TRI-PARTY AGREEMENT

Change Notice Number TPA-CN- 0893	TPA CHANGE NOTICE FORM	Date: June 26, 2020
Document Number, Title, and Revision: DOE/RL-2011-104, <i>Characterization Sampling and Analysis Plan for the 200-DV-1 Operable Unit, Rev. 0</i>		Date Document Last Issued: January, 2012
Approved Change Notices Against this Document: TPA-CN-668, TPA-CN-724, TPA-CN-0748, TPA-CN-0884		
Originator Mark E. Byrnes		Phone: 509-373-3996

Changes are required to the DOE/RL-2011-104, *Characterization Sampling and Analysis Plan for the 200-DV-1 Operable Unit*, in order to conduct resampling and discrete analysis of soil samples from waste site 216-S-13.

Figure 3-29. Conceptual Passive Soil Gas Sampling Grid for the 216-S-13 Crib

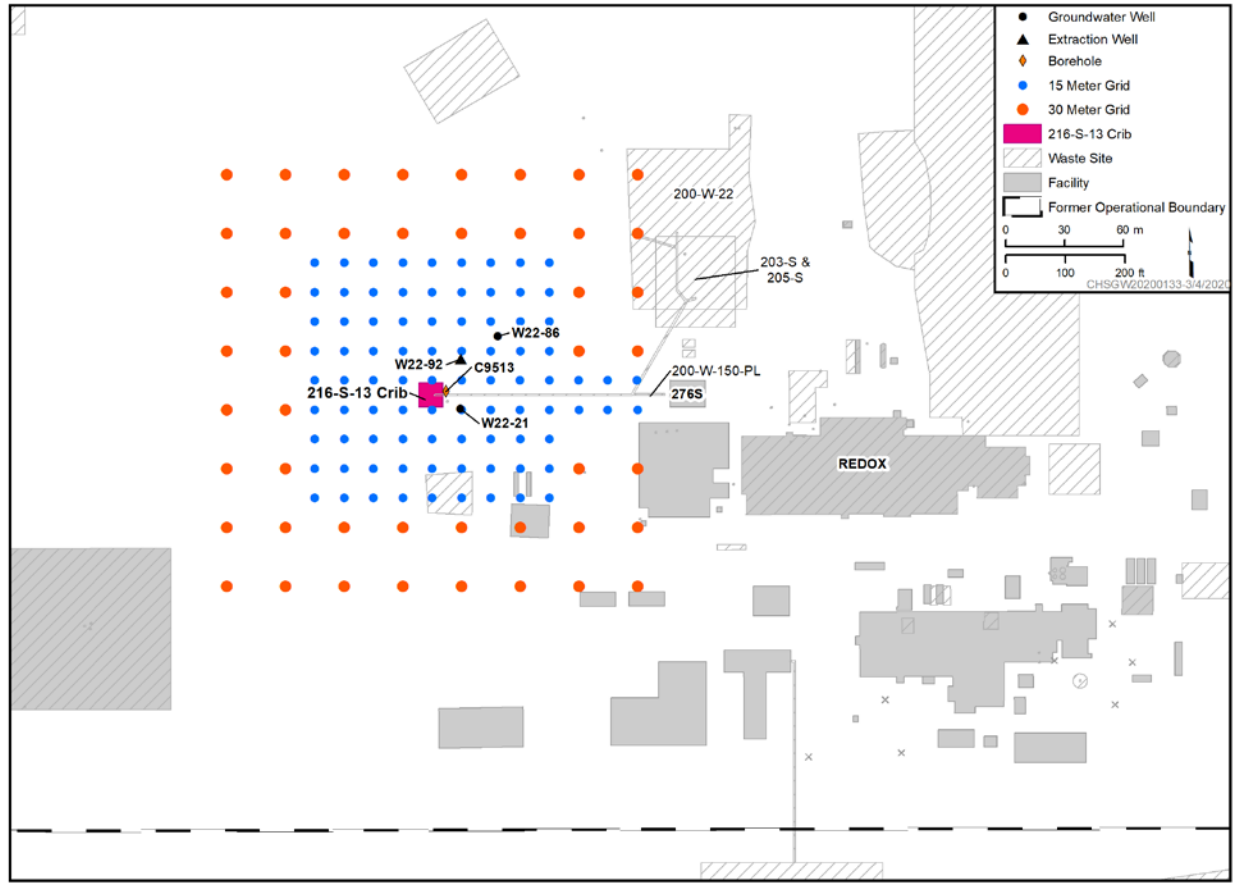
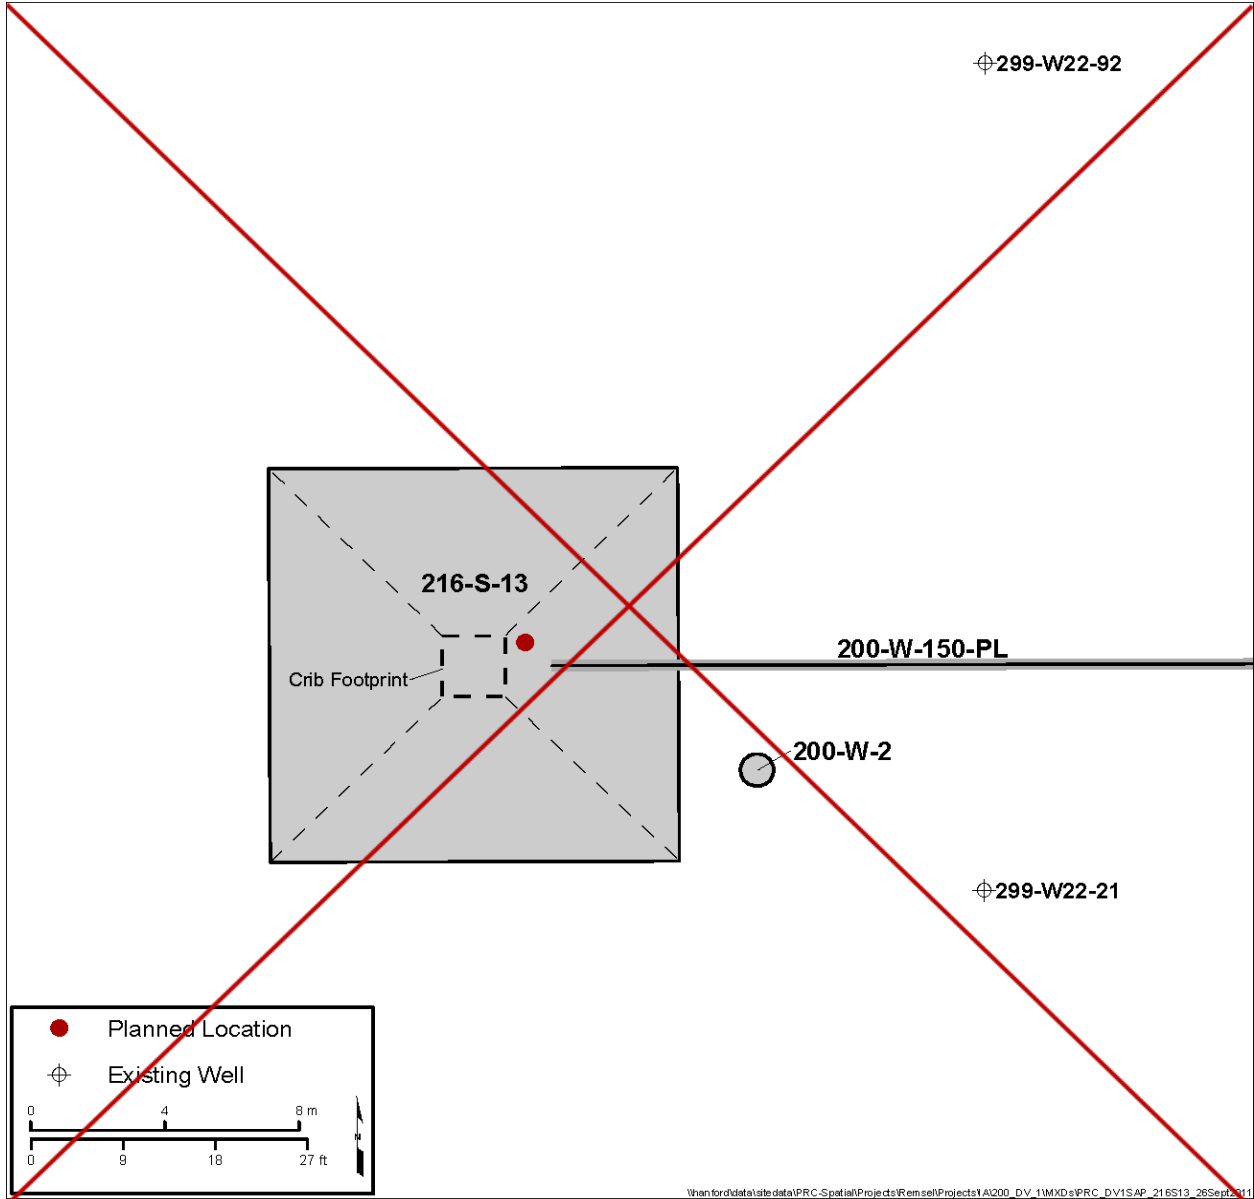
- Revised the text in Section 3.1.3.2 to include general information for the new borehole for resampling. In addition added information on passive soil gas sampling and pore fluid sampling
- Added Figure 3-29 showing conceptual layout of the passive soil gas sampling grid
- Revised Figure 3-30 to add the new borehole
- Revised Figure 3-31 to add the new borehole and proposed sampling intervals
- Revised Table 3-17 by adding a new line for the new borehole and updating the sample numbers

As determined by the project, a passive soil gas sampling grid may be established in the area surrounding the 216-S-13 crib. A conceptual layout of the sampling grid is shown in Figure 3-29. The soil gas sampling equipment and process are described in section 3.2.6, Passive Soil Gas Sampling. The soil gas sampling grid will be installed and sampled in accordance with established procedures.

Figure 3-30. 216-S-13 Crib Data-Collection Locations

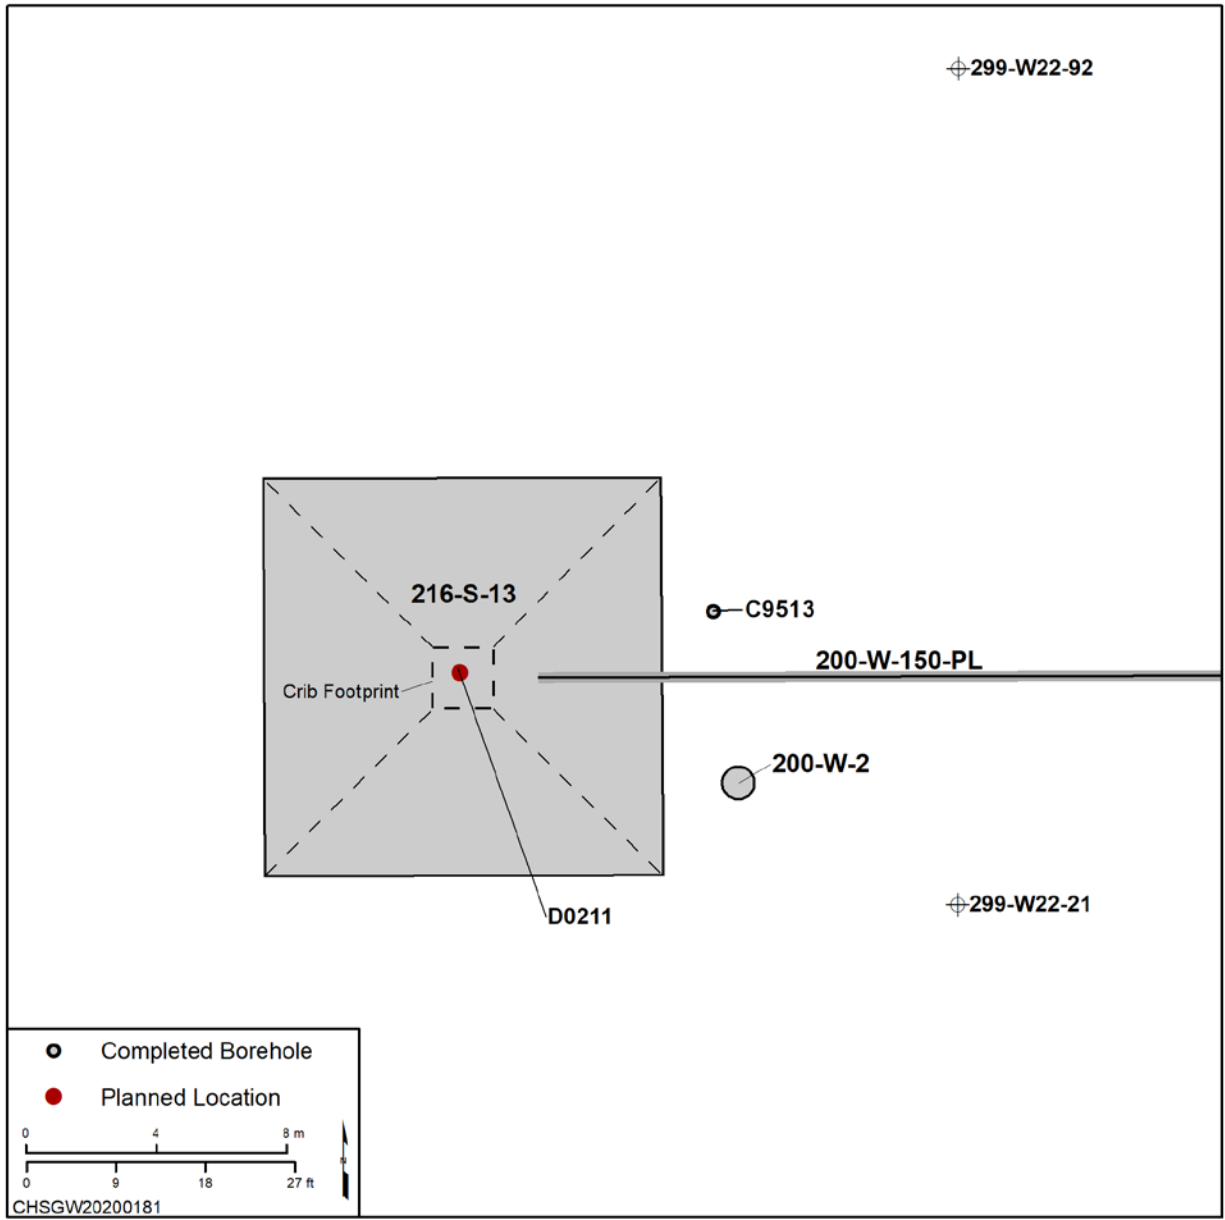
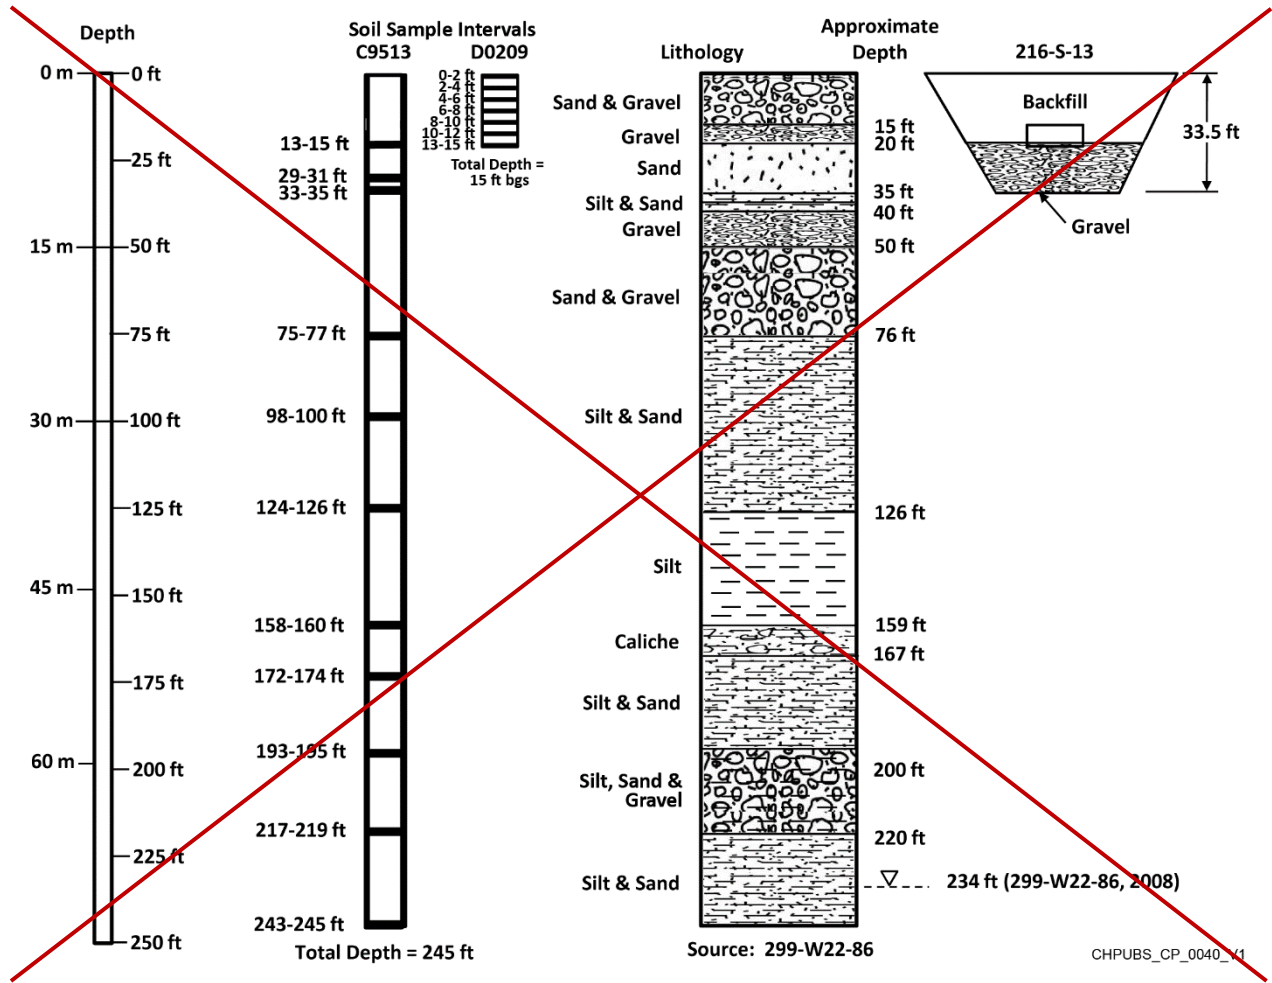
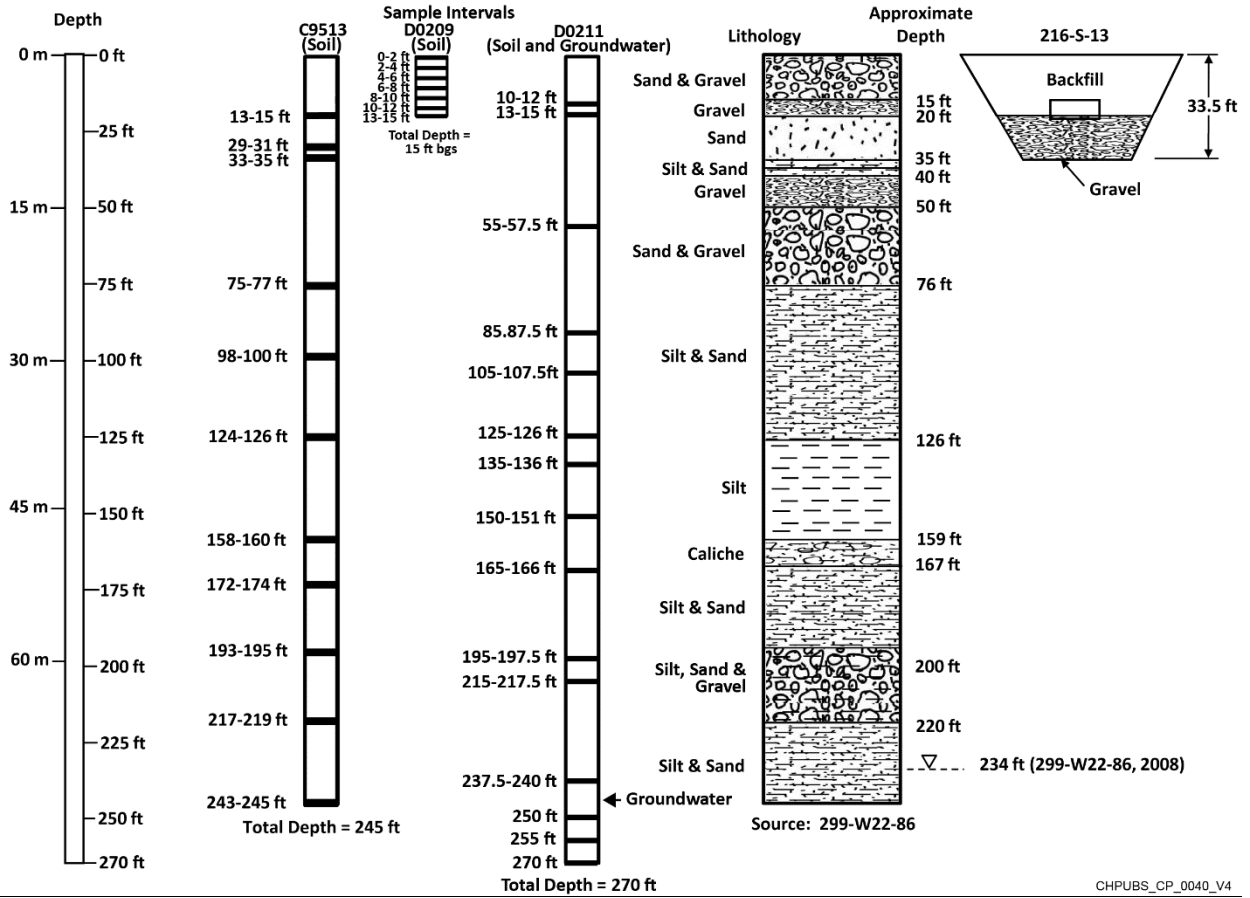
A borehole will be drilled through the approximate center of the 216-S-13 crib to a depth of up to 7.7 m (25 ft) below the water table (Figure 3-30) to evaluate the applicable radiological, inorganic, and organic COPCs (see Table 1-2, DOE/RL-2011-104). The new borehole proposed for the center of the 216-S-13 crib will be drilled following the same protocols employed during the first phase of 200-DV-1 characterization. These protocols include:
